Appendix B – Public Response Documents

Comments To The Draft Resource Management Plan and Environmental Impact Statement for the Kemmerer Field Office Planning Area, Wyoming

Draft Resource Management Plan and Environmental Impact Statement for the Kemmerer Field Office Planning Area

Comments on Air Quality Technical Support Document for the Draft Resource Management Plan and Environmental Impact Statement for the Kemmerer Field Office Planning Area

Figure 1. The efficiency and amount of ammonia production of the catalyst varies with the air fuel ratio. The traditional window of control is small and is centered at the point where NOx and CO efficiencies are equal (The E Point) which is located slightly rich of stoichiometric (1.017 phi).

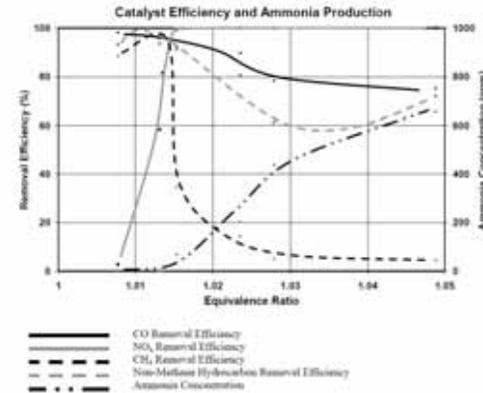
The following figure indicates how sensitive the NOx removal rate is to the air fuel setting. In addition, it has been demonstrated that if the AFR drifts rich, NOx removal is accomplished by producing NH3. From an air quality perspective, shifting from NO emissions to NH3 is not desirable.

As indicated in the above figure "During normal steady state operation, the catalyst behaved in a predictable manner. The plots of removal efficiency and ammonia production shown in figure one illustrate the control problem. The window of control for NOx and CO, even at only 80% removal efficiency is only about one percent of phi. In addition the NOx / Non-methane hydrocarbon window at 80% is half of that, and the NOx / Methane window is less than a quarter of a percent of phi. Also, ammonia formation rapidly increases as the air/fuel ratio moves rich of the E point. However, using very precise control of the air/fuel ratio, it is possible to achieve high removal efficiencies of both NOx and CO. At the E point, the efficiency of both constituents is close to 95%."³
